Amendments to the Drawings

REMARKS

Figure 1
 Prior Art

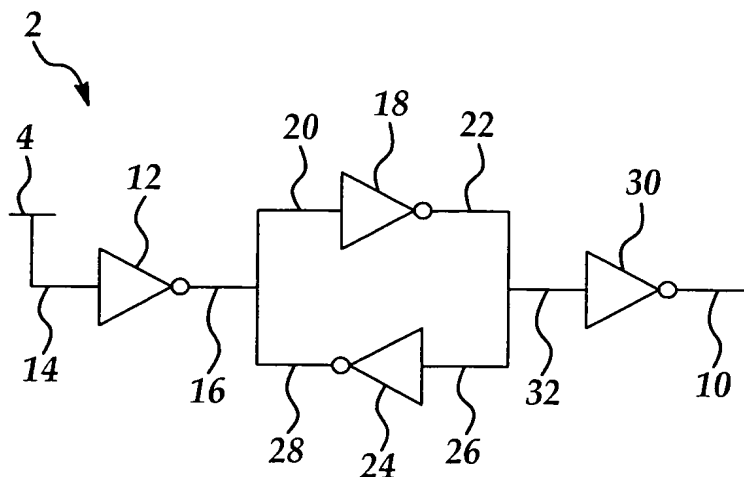
In the OA, Examiner objected to omission of a "Prior Art" legend with reference to Figures 1-2. Accordingly, a Prior Art legend has been added to Figures 1-2 as shown the Appendix following page 20 of this Response. Thus, the objections to the Drawings have been obviated.

The attached sheet of drawings includes changes to Figures 1-2. This sheet, which includes Figures 1-2 replaces the original sheet including Figures 1-2. In amended Figures 1-2, the previously omitted legend "Prior Art" has been added.
